**STAFF REVIEW AND RECOMMENDATIONS
PUBLIC HEARING
JULY 22, 2026**

ABBREVIATED PLAT: AIR LIQUIDE INDUSTRIAL PARK LOT 3A & LOT 4A

REVIEWED BY: CAYMAN REYNOLDS **CASE #:** 2026-073

Preliminary Plat of
Lot 3A & Lot 4A,
Air Liquide Industrial Park Subdivision
a subdivision of Lot 2A Air Liquide Industrial Park Subdivision

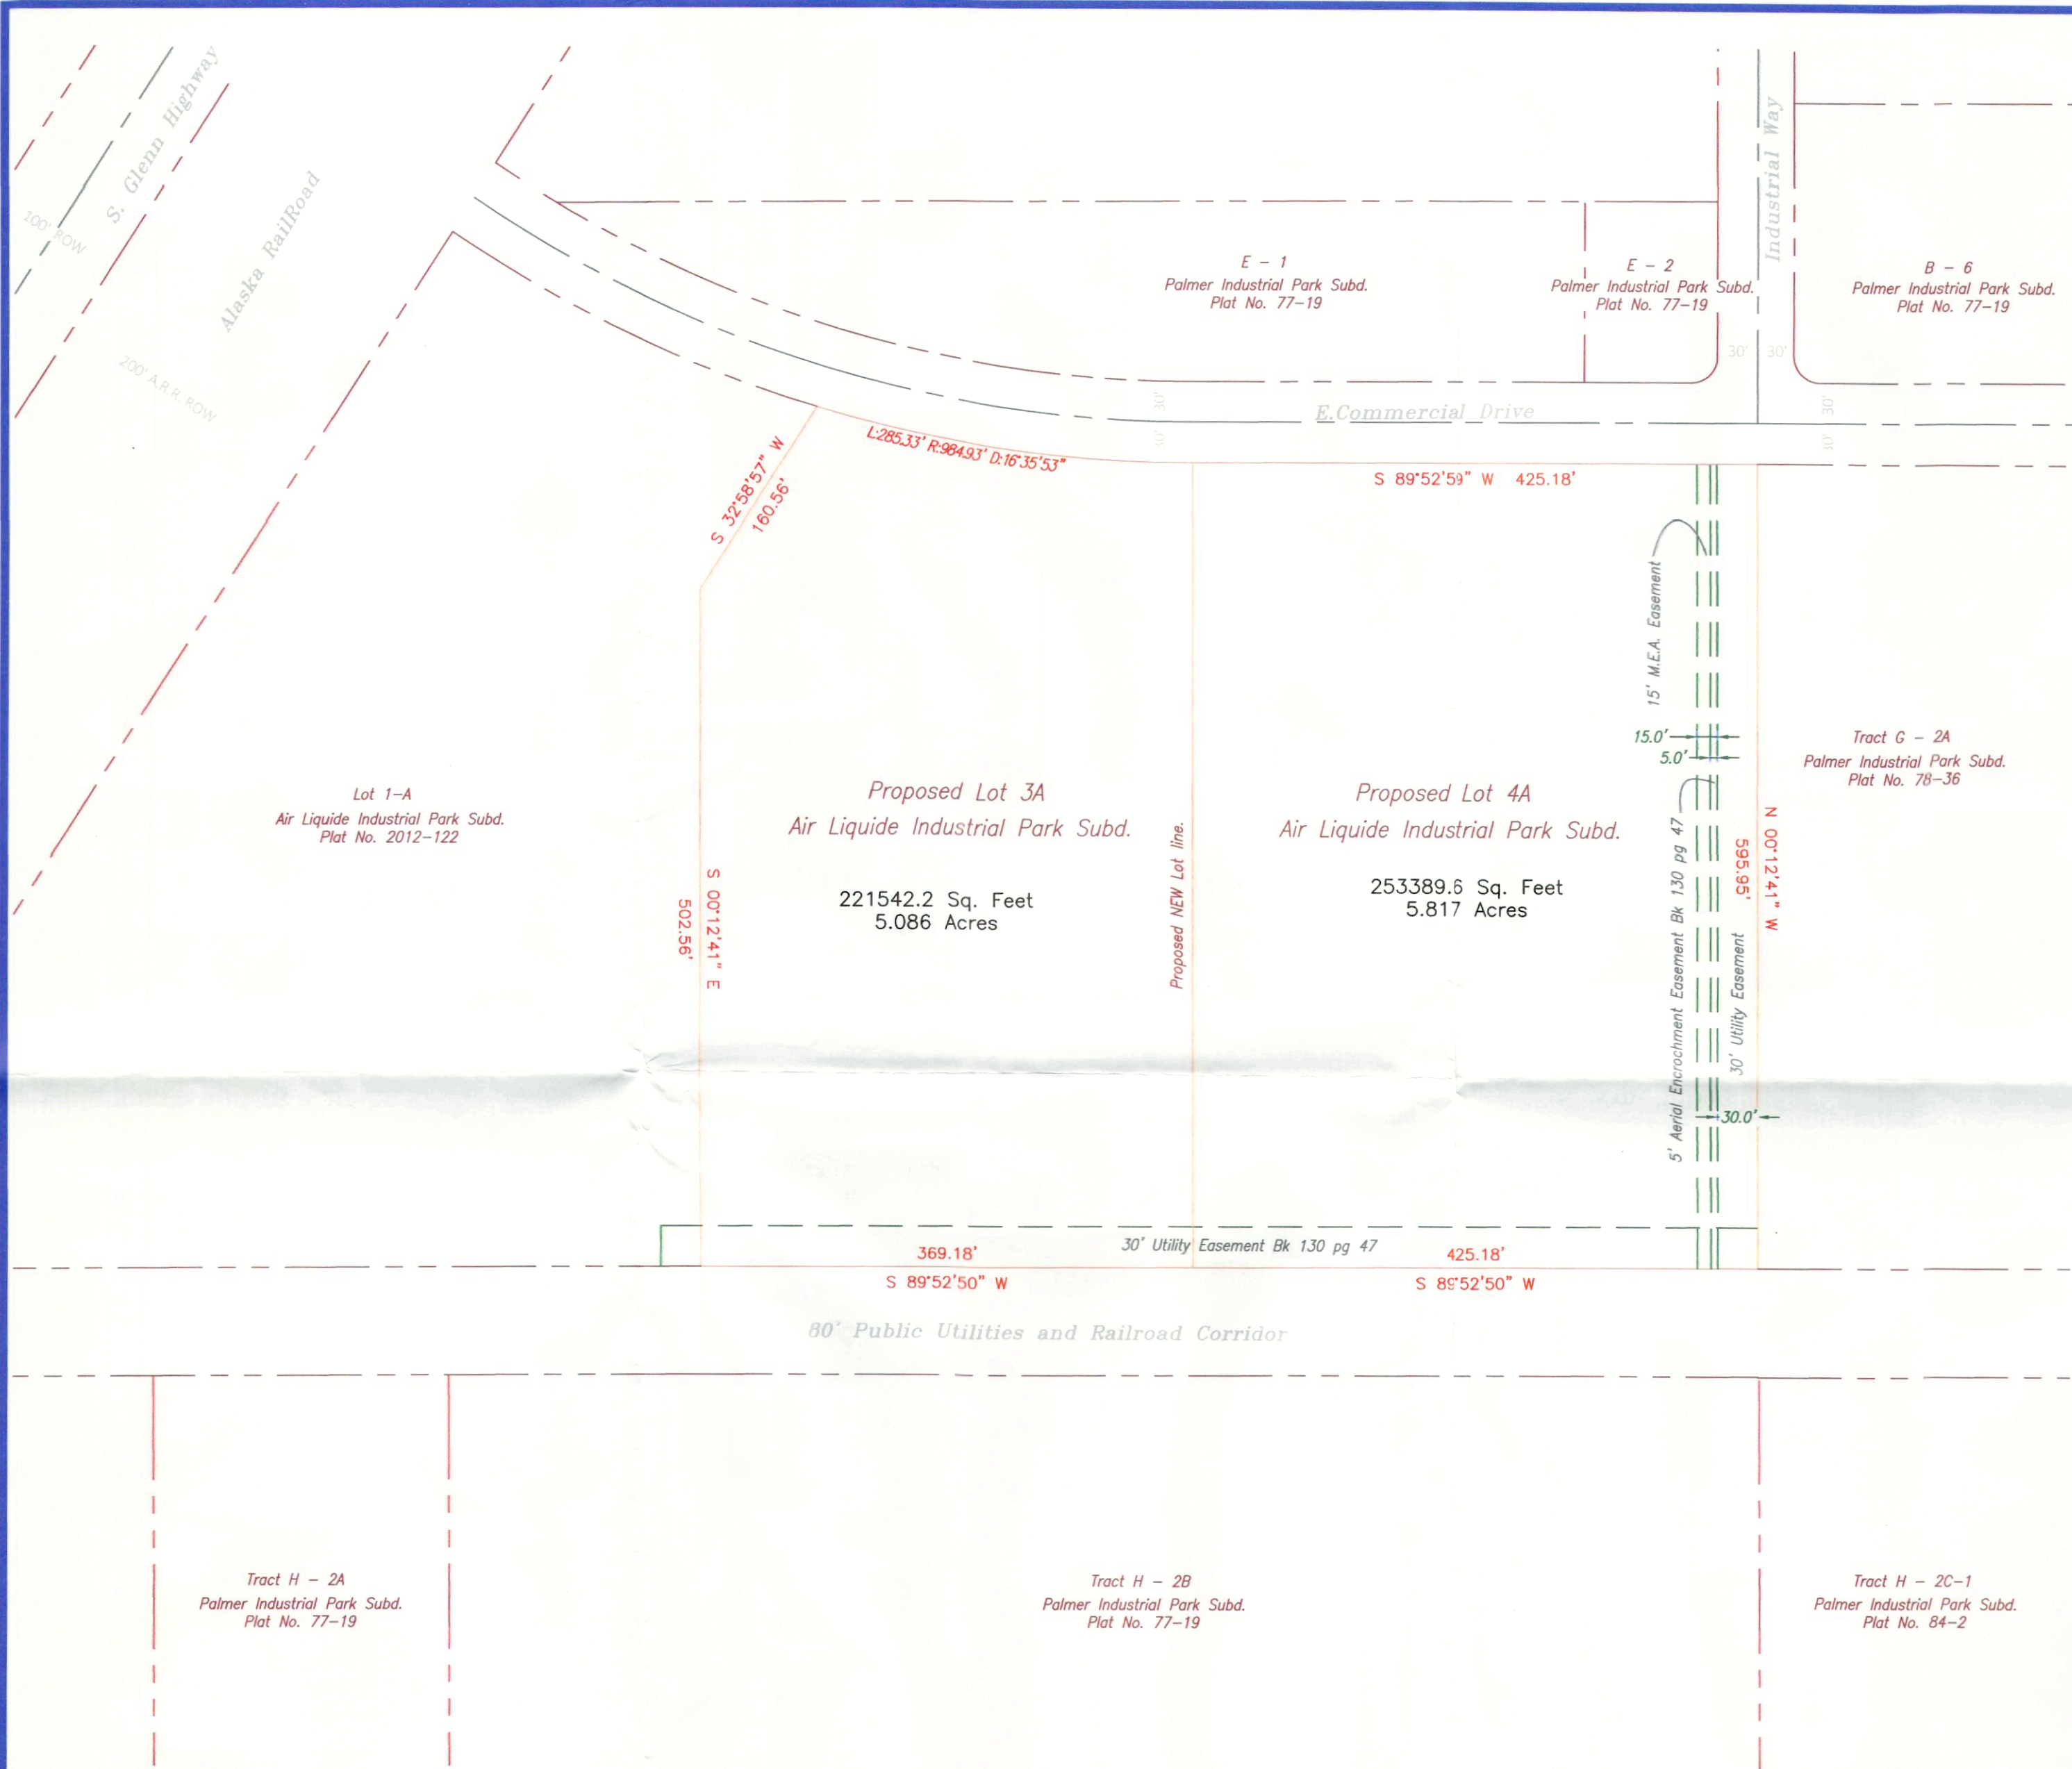
1. City Manager: No comment.
2. Building Inspector: No comment.
3. Community Development: No comment.
4. Fire Chief: No comment.
5. Public Works: As part of this action, connection to City of Palmer water and sewer is required. No on-site water wells or septic systems are authorized.
6. Planning and Zoning Commission: The proposed platting action is scheduled to be reviewed at the July 16, 2026, Planning & Zoning Commission meeting; any additional comments will be forwarded at this time.

- **Air Liquide Industrial Park; Plat #2012-122; PA 12 New Horizons Telecom (Commercial Drive)**
 - No objection to proposed lot division.
 - Consider connectivity to proposed pathway along the southern border of the property.

- Please be advised this plat is within the boundary of the Inner and Outer Springer Loop Separated Pathway Project, which may be built in the railroad corridor easement. For

Thank you for bringing this project to our attention and for allowing us to comment. The United States Army Corps of Engineers does have a comment regarding the proposed Air Liquide Industrial Park subdivision project. Based on aerial imagery, the Matanuska-Susitna Borough Wetlands mapper, and the National Wetlands Inventory mapper, it appears that there may be aquatic resources located on the proposed Lot 3A.
